# Vibration from Engine after Cold Soak

YEAR(S)	MODEL(S)	ADDITIONAL INFORMATION
2010 – 2011	Prius

Some 2010 – 2011 model year Prius vehicles may experience an abnormal vibration or droning noise with the Internal Combustion Engine (ICE) ON after extended cold soak in extremely low temperature conditions until the engine bay begins to warm up. The right rear engine mount has been updated to address this condition.

**Figure 2.**

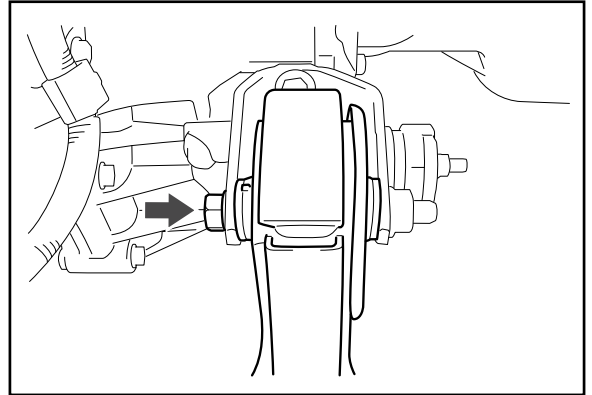
3. Properly support the engine assembly with a jack and remove the two bolts from the right rear engine mount.
4. Install the new rear engine mount and properly torque bolts.

**Torque: 95 N\*m (969 kgf\*cm, 70 ft\*lbf)**
